UNITED STATES PATENT AND TRADEMARK OFFICE

APPLICATION NO.	FILING DATE	FIRST NAMED INVENTOR	ATTORNEY DOCKET NO.	CONFIRMATION NO.
09/918,886	07/30/2001	Ting K. Yee	20852-05682	3294
35690	7590	02/27/2006	EXAMINER	
MEYERTONS, HOOD, KIVLIN, KOWERT & GOETZEL, P.C.			KIM, DAVID S	
P.O. BOX 398			ART UNIT	
AUSTIN, TX 78767-0398			PAPER NUMBER	
			2633	
DATE MAILED: 02/27/2006

Office Action Summary	Application No. 09/918,886	Applicant(s) YEE ET AL	
	Examiner David S. Kim	Art Unit 2633

DETAILED ACTION

FIG. 1

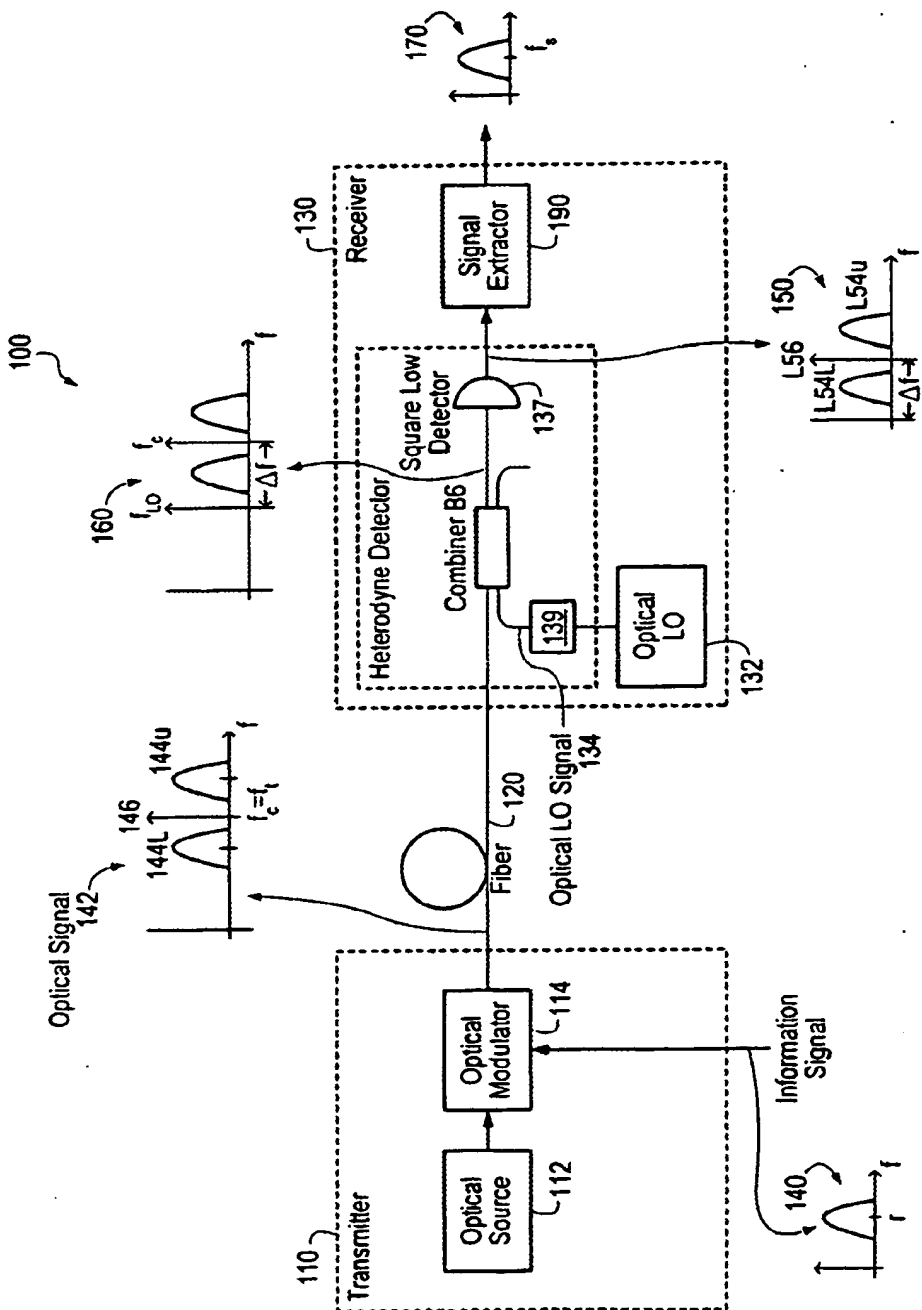
In Fig. 1, replace the frequency label "r" with "f_r" under the spectrum 140. See paragraph [0056] for support.

In Fig. 1, label the heterodyne detector with "180" as in the old Fig. 1 filed on 30 July 2001. See paragraph [0055] for support.

In Fig. 1, replace reference characters "L54L", "L54u", and "L56" with "154L", "154u", and "156", respectively, as in old Fig. 1 filed on 30 July 2001. See paragraph [0059] for support.

In Fig. 1, delete " f_s " under the reference character "170". Paragraph [0059] teaches that component 170 may be offset from f_s instead of being located at f_s as shown in Fig. 1.

In Fig. 1, replace "B6" with "136" and replace "Low" with "Law". See paragraph [0062] for support.

FIG. 2

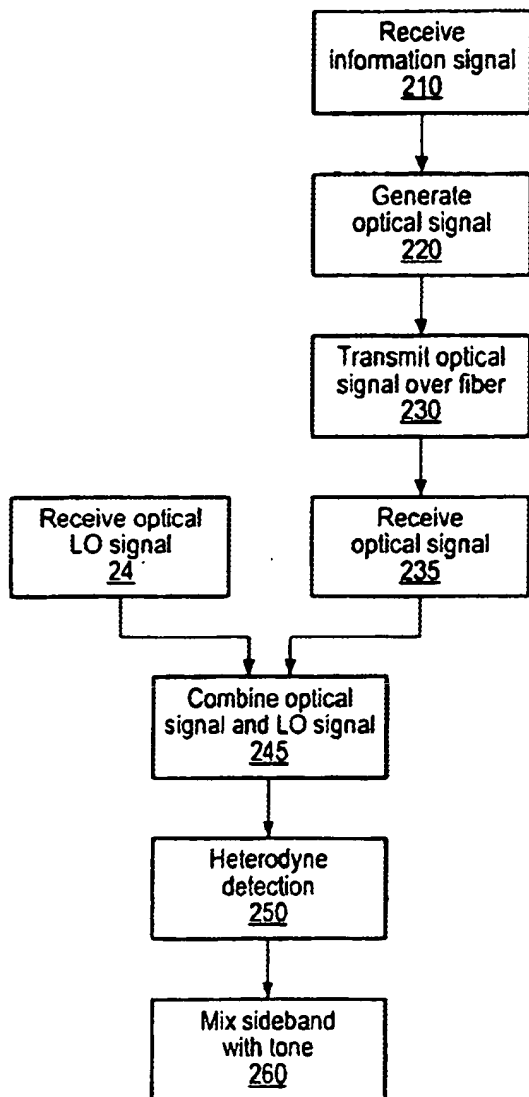
In Fig. 2, add a reference character "200" that points to the entire method. See paragraph [0028] for support.

In Fig. 2, replace reference character "24" with "240" as in old Fig. 2 filed on 30 July 2001. See paragraph [0059] for support.

FIG. 4

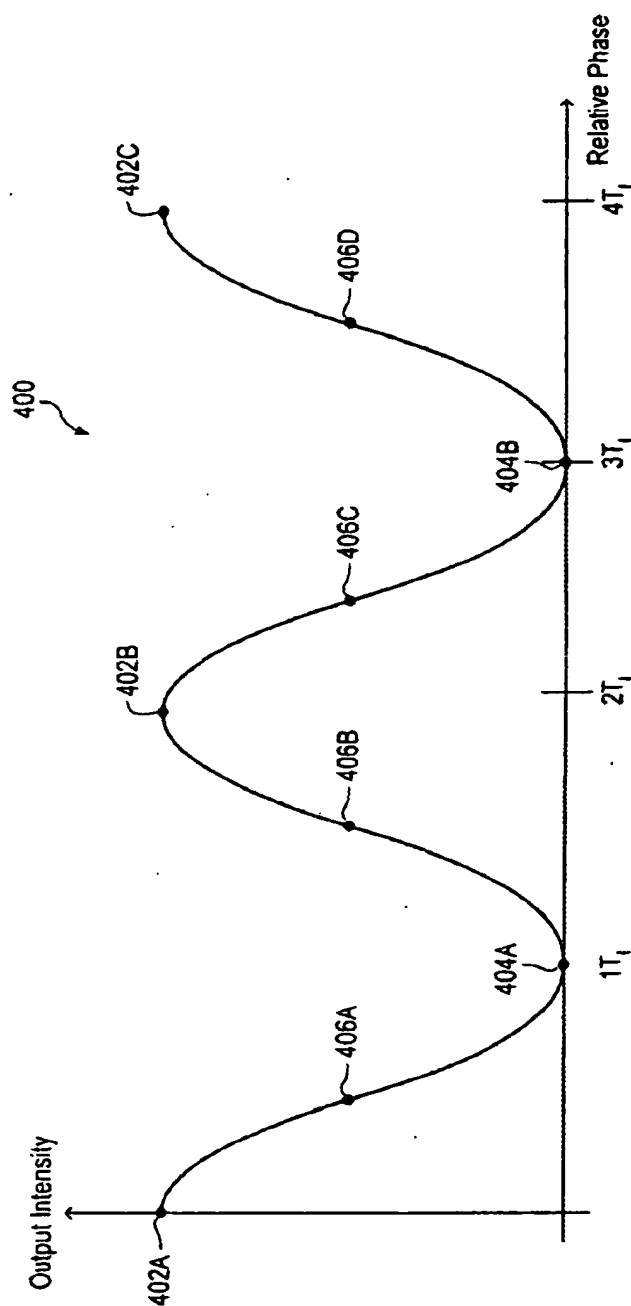
In Fig. 4, replace all instances of " T_i " with " π " as shown in old Fig. 4 filed on 30 July 2001. See paragraph [0067] for support.

FIG. 5

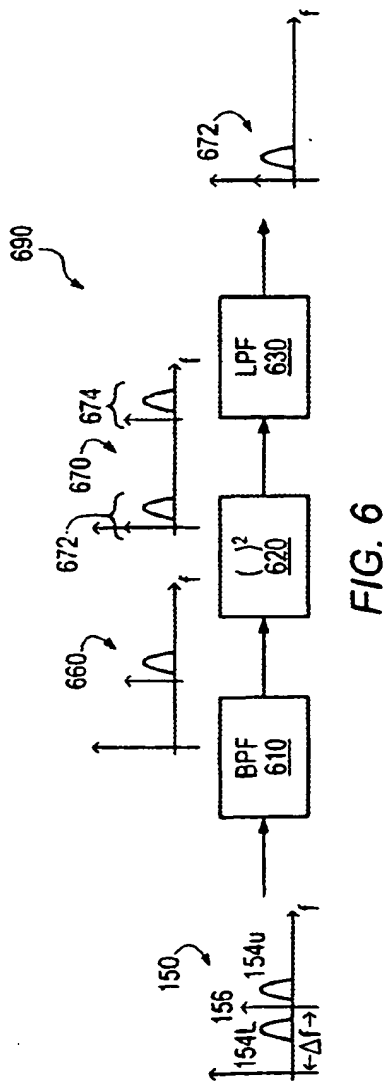
In Fig. 5, replace "Biased off Null" with "Biased at Null" as shown in old Fig. 5 filed on 30 July 2001.

FIG. 9

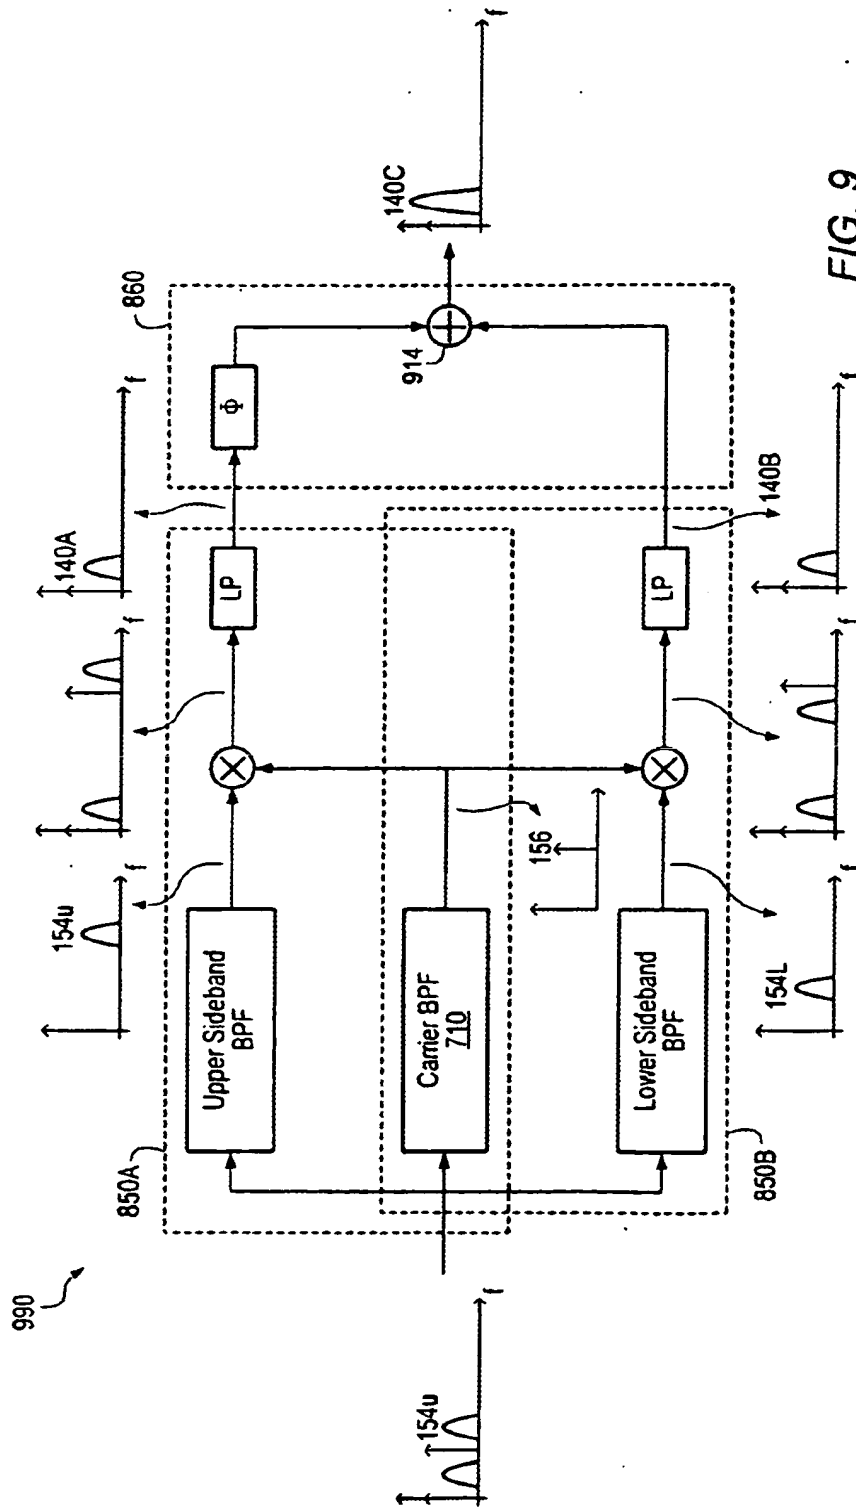
In Fig. 9, the input signal is missing labels "154L" and "156". See how Figs. 6-7 provide these labels.

In Fig. 9, add a reference character "720" that points to the upper multiplier. Also, add a reference character "720" that points to the lower multiplier. See paragraph [0079] for support.

In Fig. 9, add a reference character "912" that points to the phase shifting element as shown in old Fig. 9 filed on 30 July 2001. See paragraph [0080] for support.

FIG. 10

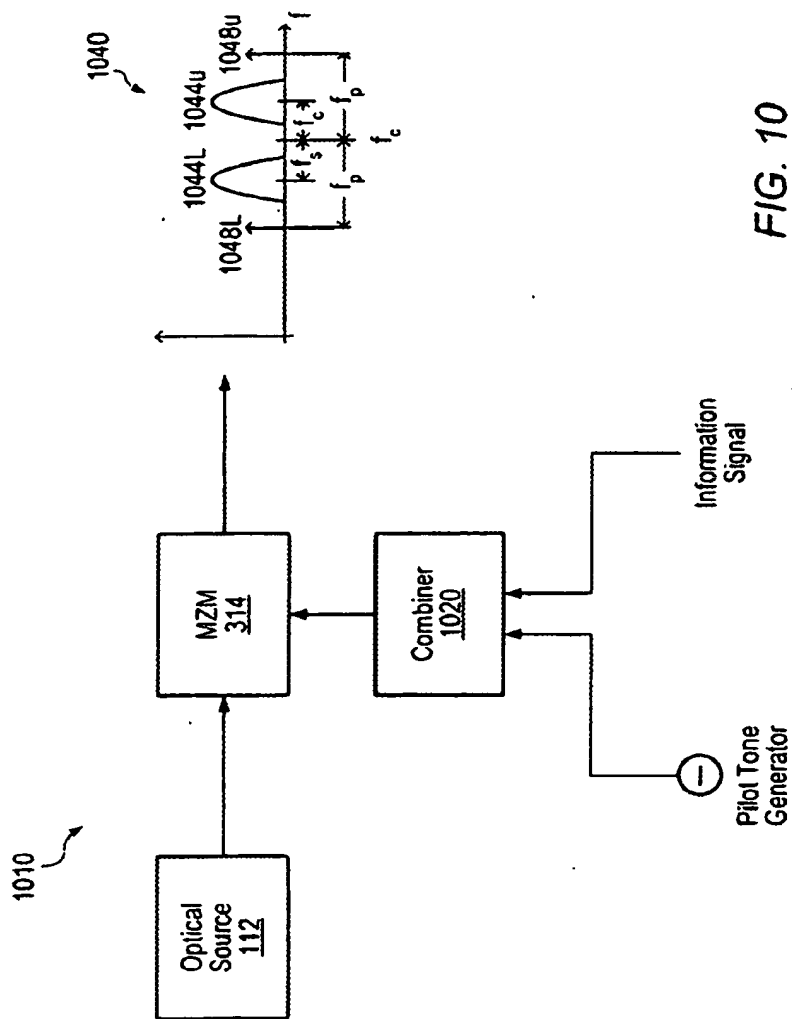
In Fig. 10, label the Pilot Tone Generator with "1030" as in old Fig. 10 filed on 30 July 2001. Also, label the Information Signal with "140" as in old Fig. 10 filed on 30 July 2001. See paragraph [0081] for support.

In Fig. 10, the spectrum drawing shows a label " f_c " next to a label " f_c ". Replace " f_c " with another instance of " f_c " so there are two instances of " f_c " next to each other as shown in old Fig. 10 filed on 30 July 2001.

FIG. 12

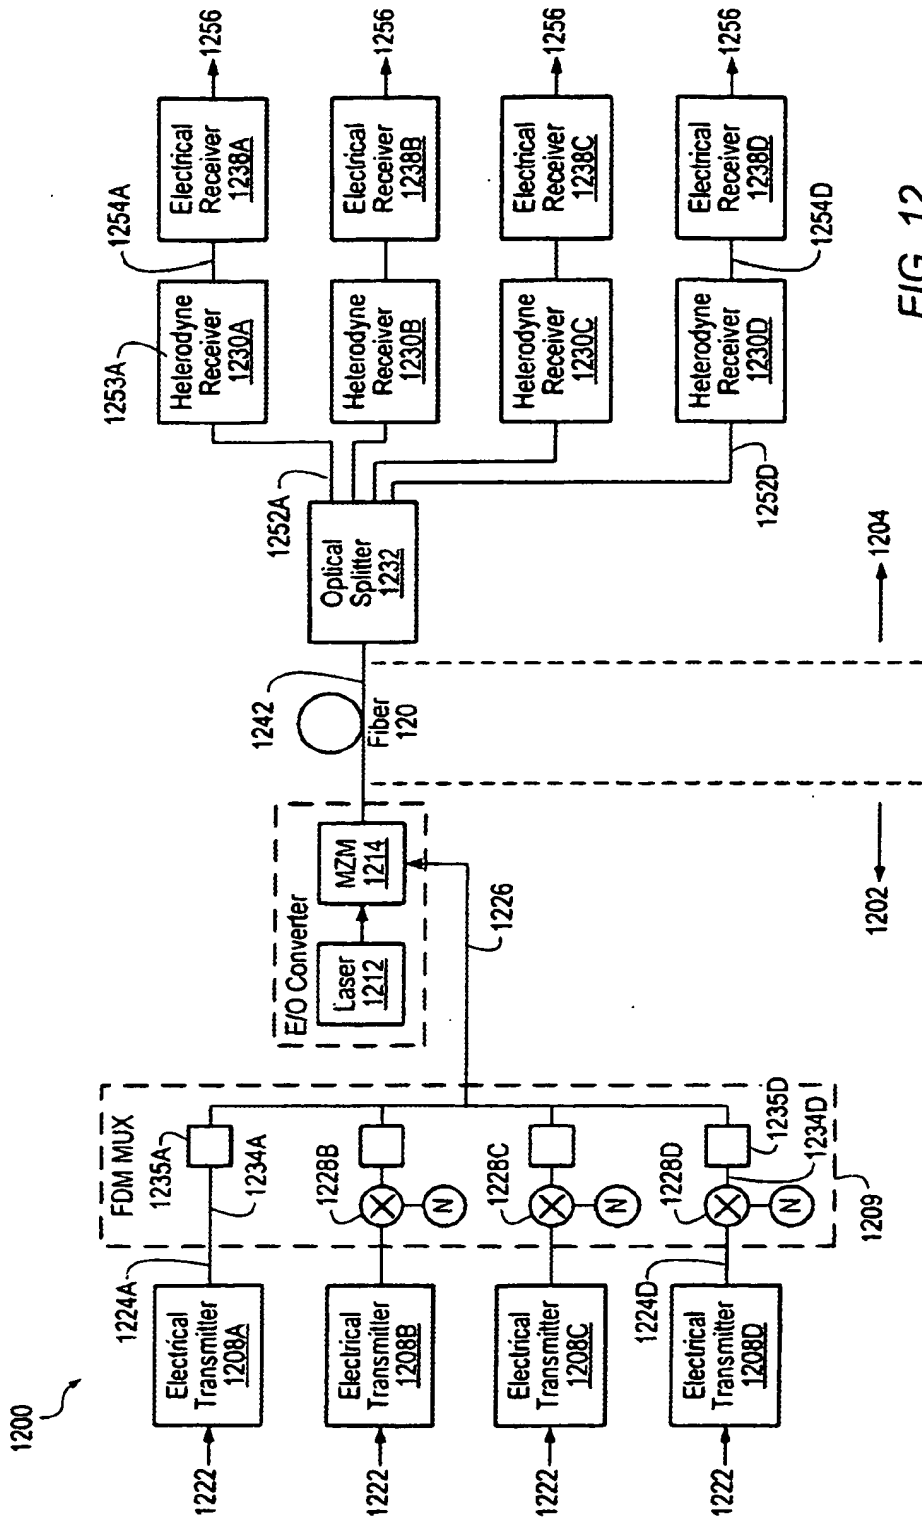
In Fig. 12, label the E/O Converter with "1210" as in old Fig. 12 filed on 30 July 2001. See paragraph [0092] for support.

FIG. 13A

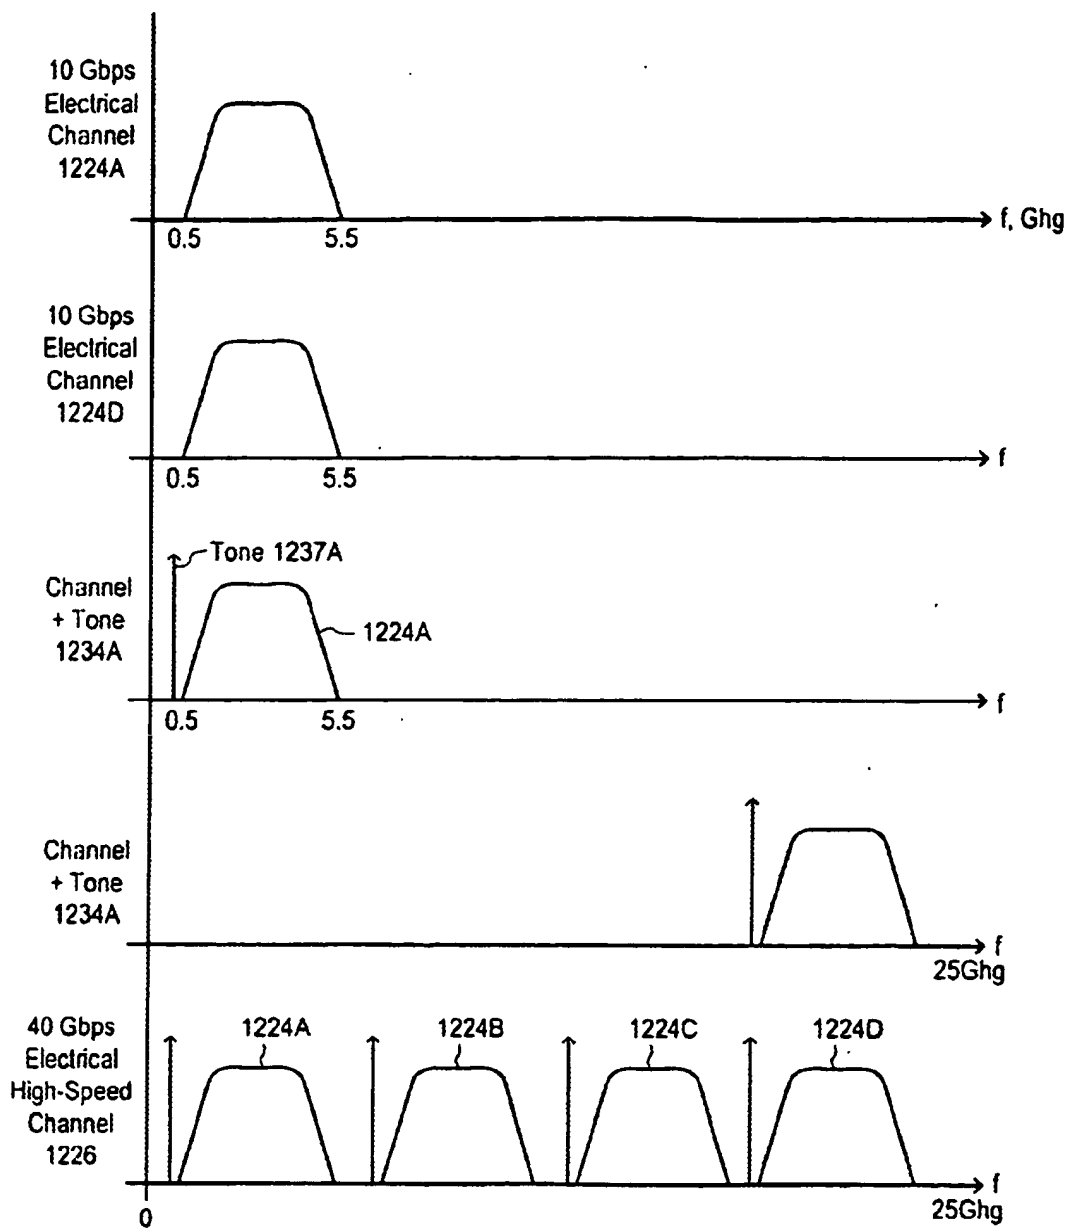
In Fig. 13A, there are two instances of "1234A". Replace the lower instance with "1234D" as in old Fig. 13A filed on 30 July 2001. See paragraph [0093] for support.

FIG. 14A

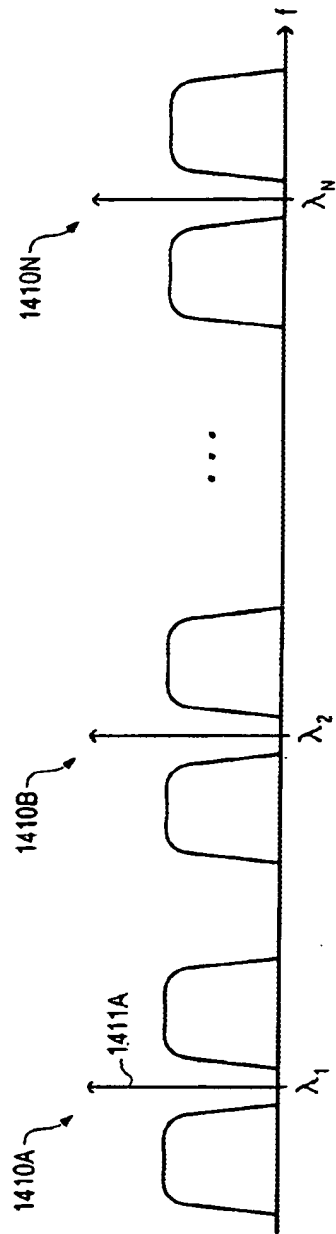
In Fig. 14A, label the lower sideband to the left of optical carrier 1411A with "1412A(L)" and label the upper sideband to the right of optical carrier 1411A with "1412(U)" as shown in old Fig. 14A filed on 30 July 2001. See paragraph [0086] for support.

FIG. 17

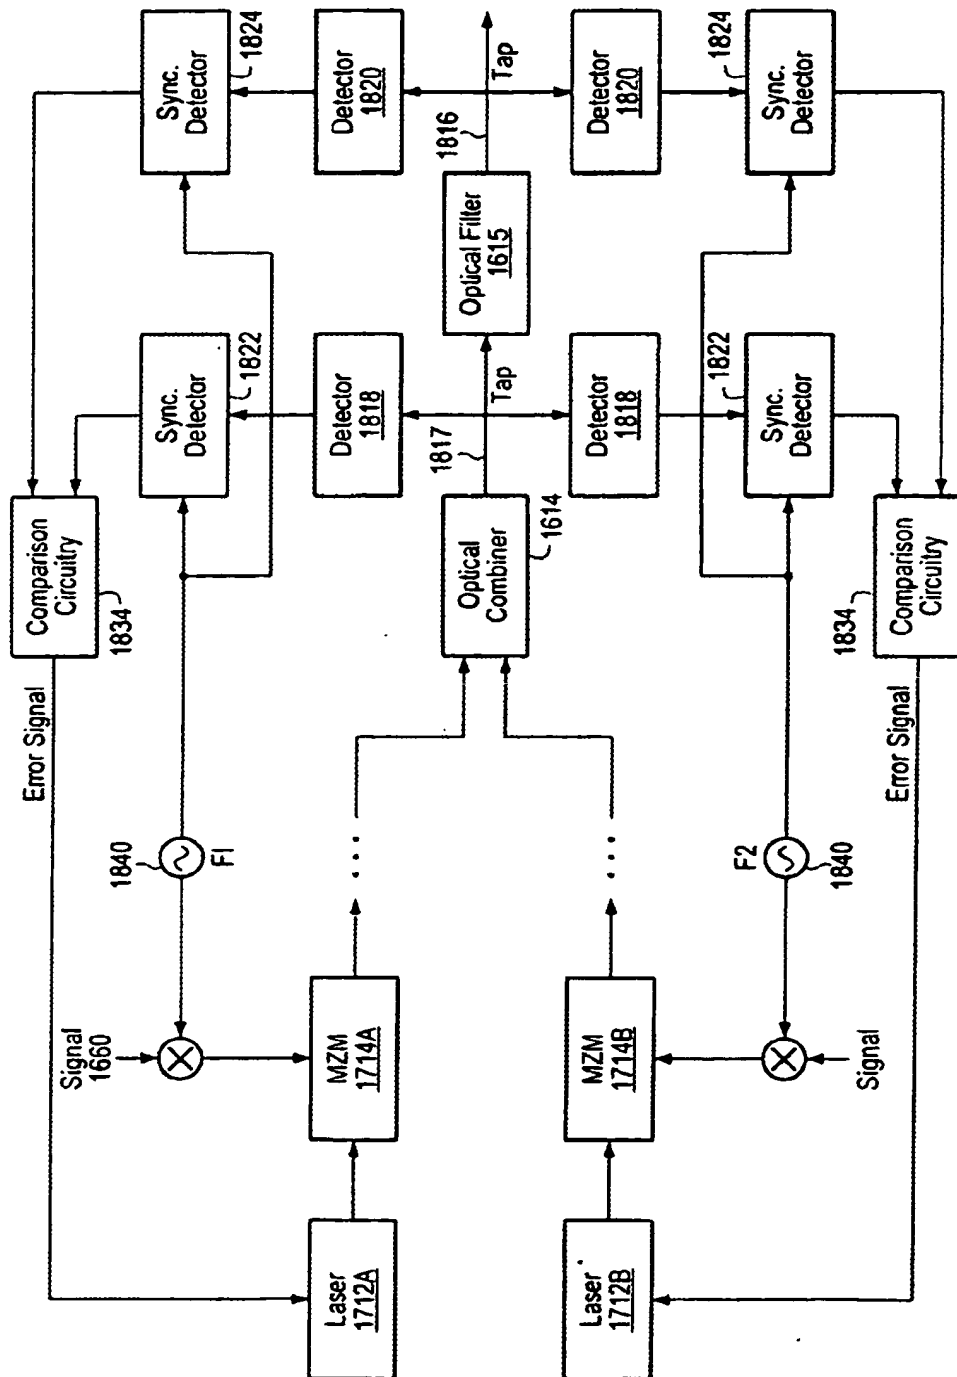
In Fig. 17, remove reference character "1700" and its lead line since it does not appear in the specification.
